DRAINAGE CERTIFICATION FOR LOT 11 UNIT FIVE LOOP INDUSTRIAL DISTRICT (8301 JEFFERSON NE)

GRADING/DRAINAGE PLAN

PROJECT NAME	REVISIONS
OFFICE/WAREHOUSE 8301 JEFFERSON NE ALBUQUERQUE, NM	NO. 1 DATE 6/20/2000 ENGINEER CERTIFICATION
DRAWING TITLE

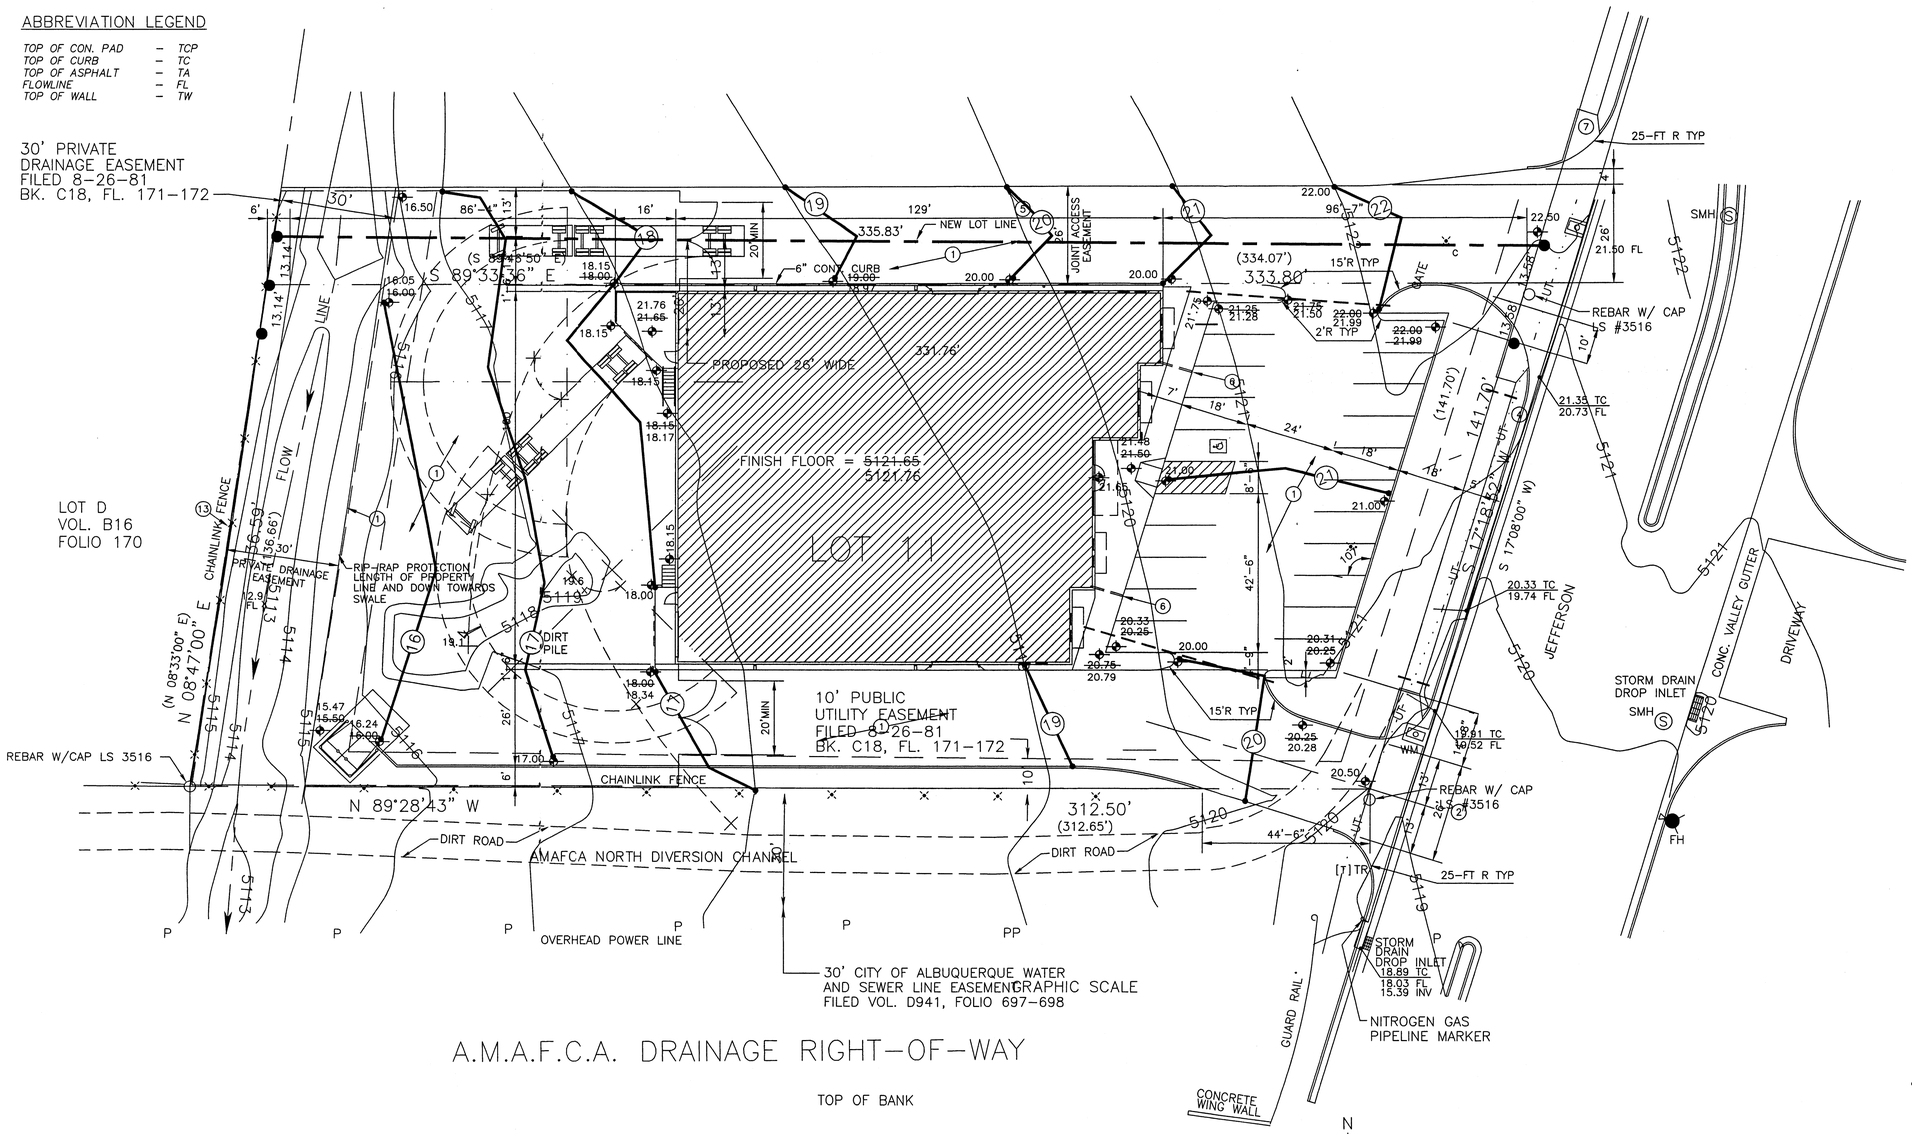
AS INDICATED BY THE AS-BUILT INFORMATION SHOWN HEREON: 8301 JEFFERSON NE HAS BEEN GRADED AND DRAINED IN SUBSTANTIAL COMPLIANCE WITH THE APPROVED PLAN DATED 11/18/99 WITH THE FOLLOWING DEVIATION.

1. THE APPROVED GRADES WITHIN THE TWO DRIVEPADS WHERE ALTERED SLIGHTLY PER THE CITY TRANSPORTATION DEPT.

THIS DEVIATION DOES NOT IMPACT THE DRAINAGE CONCEPT IN ANY WAY THE SITE DRAINAGE WILL FUNCTION IN ACCORDANCE WITH THE PATTERNS ESTABLISHED BY THE APPROVED PLAN. THEREFORE A PERMANENT CERTIFICATE OF OCCUPANCY IS HEREBY RECOMMENDED. THE AS-BUILT INFORMATION SHOWN HEREON WAS OBTAINED BY ME OR UNDER MY DIRECT SUPERVISION AND IS TRUE AND CORRECT TO THE BEST OF MY KNOWLEDGE AND BELIEF.
